Memorandum

DATE January 16, 2018 **FILE NO.** WMI# 14-293
City File # D11-009 2017

RE 400 – 430 Ferndale FSR Addendum

BARRIE PUBLIC UTILITIES COMMISSION VALVE LOCATION DRAWING

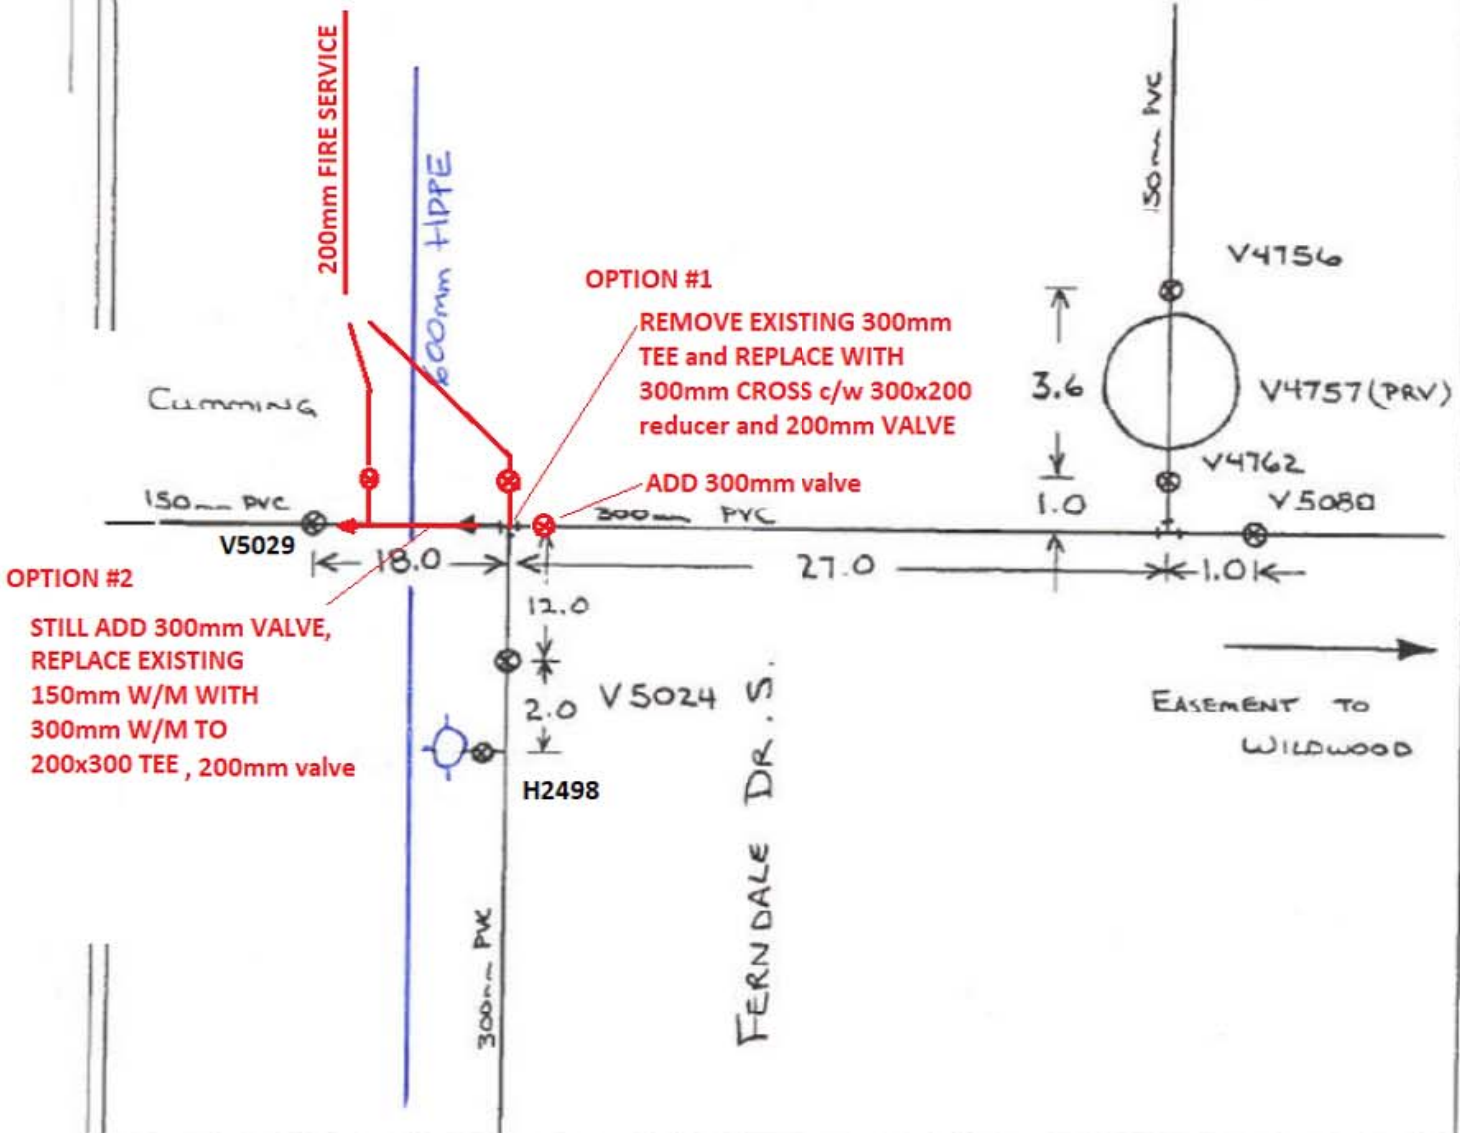
- FUS calculation as reviewed by the City.
- Fire Flow calculations as reviewed by the City.
- Water Supply calculations as reviewed by the City.
- Water connection location sketch has provided by the City. The detailed design drawings are based upon Option #1.

In summary, the existing 150mm watermain on Hawthorne Crescent is adequate for providing domestic water for the proposed development, however it is not adequate to provide fire protection. As a result, the City reviewed and confirmed that the existing 300mm watermain on Ferndale Drive at the Cumming Drive intersection will be sufficient to provide fire protection per the FUS calculations. As such, the detailed design has been revised to reflect the attached sketch, Option #1
